GFA AIRWORTHINESS DIRECTIVE

TYPE AFFECTED: Cirrus and Cirrus VTC

SUBJECT: Fatigue life limits on the L'Hotellier coupling balls in the air brake circuit.

GFA AD 414	ISSUE: 1	18 April, 1994	Page 2 of 2
------------	----------	----------------	-------------

FIGURE 1

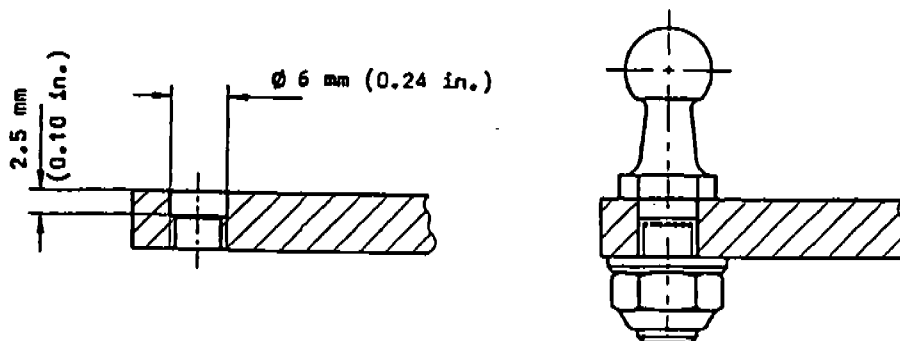
The replacement ball design has been modified by the manufacturer. The thread length is now slightly shorter and begins 2.5 mm below the flange and it is necessary to relieve the belcrank hole to allow the flange to sit flat on the belcrank surface.

2. At the first installation of the coupling ball with the new part number drill a recess 2.5 mm (0.1 in) deep and 6.0 mm (0.24 in) diameter into the side of the belcrank facing the coupling ball (drill bit included angle $\geq 115^\circ$) enabling the ball to tighten against the belcrank. See figure 1.
